Staff Report to the Plan Commission

Estates at Ravinia Meadows by Pulte

Prepared: 09/16/2025

Project: 2024-0676 – Estates at Ravinia Meadows – Special Use Permit **Amendment** for a Residential Planned Development

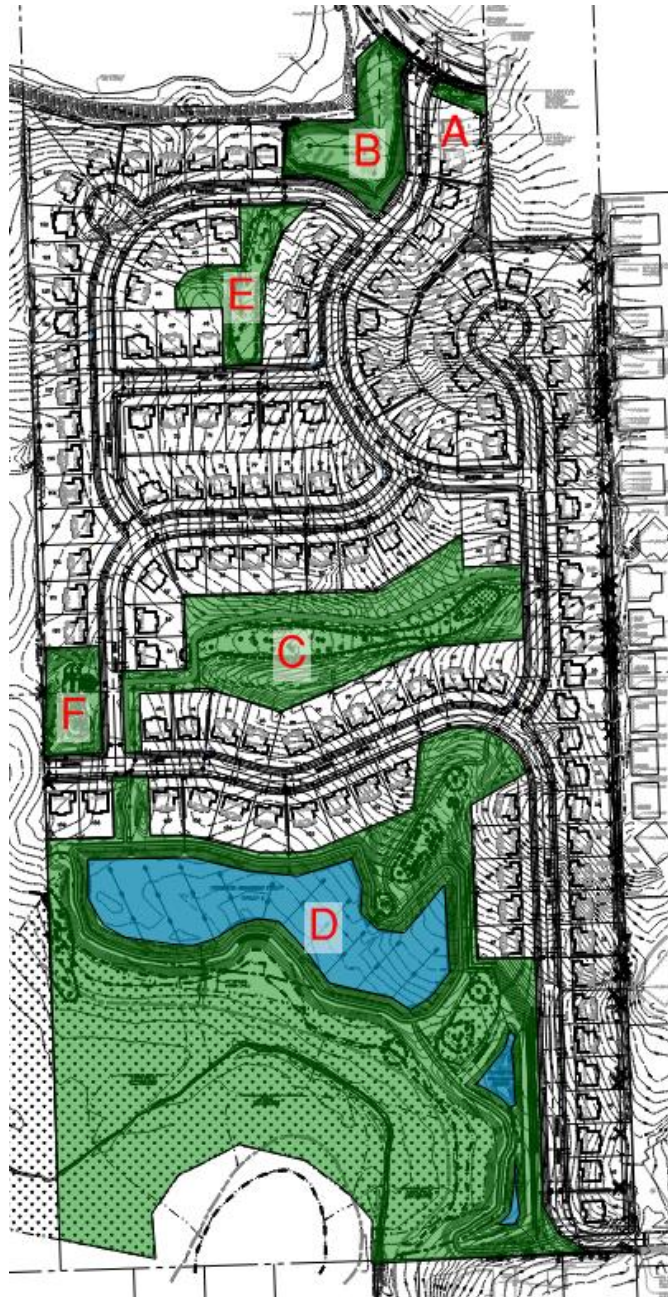
- Expansion of Outlot B to accommodate volume control for stormwater management via a bioswale for the northern portion of the Pulte project.
- Reduction in the number of housing units from 132 to 129, to accommodate expansion of Outlot B.

3 units shown in yellow have been eliminated, reducing the total number of units from 132 to 129. This allows an expansion of Outlot B which contains a bio swale providing storm water volume control for the northern portion of the site.
